SERVICE BULLETIN

S. B. NUMBER: S.B.MS17976-2-24-001

SUBJECT: Electrical Power - DC Generation - Transformer Rectifier Unit (TRU) AC Filter Capacitor Inspection

NOTE: Refer to attached illustration CH431.T.SB.01, Figure 1 when noted.

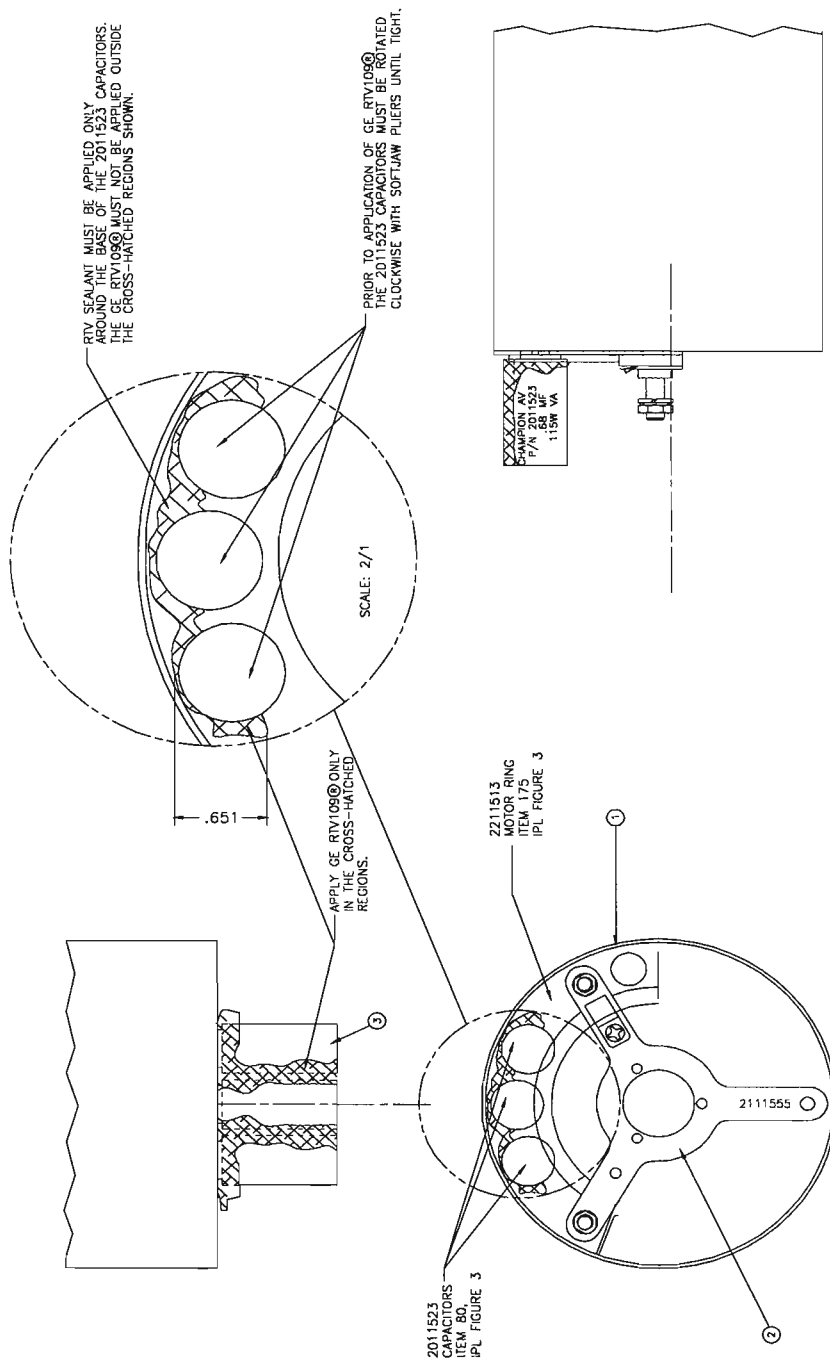
NOTE: GE RTV109 (Champion P/N: 306163) has been qualified for this modification process and is the only approved compound for this procedure.

- (1) Surface clean the area around the base of the capacitors and the motor ring with isopropyl alcohol using cotton swab or lint-free cloth.
- (2) Using GE RTV109 (Champion P/N: 306163), apply compound to crosshatched area as shown in CH431.T.SB.01, Figure 1.
- (3) Make sure no RTV compound has been applied to the seating portion of the motor ring assembly (175) where the converter end bell (5) is attached to the converter assembly.
- (4) Allow RTV compound to cure for one (1) hour (min) before the reassembly of the unit.
- (5) Position converter end bell (5) to converter assembly and replace self locking nuts (10).
- (6) Secure self-locking nuts (10).
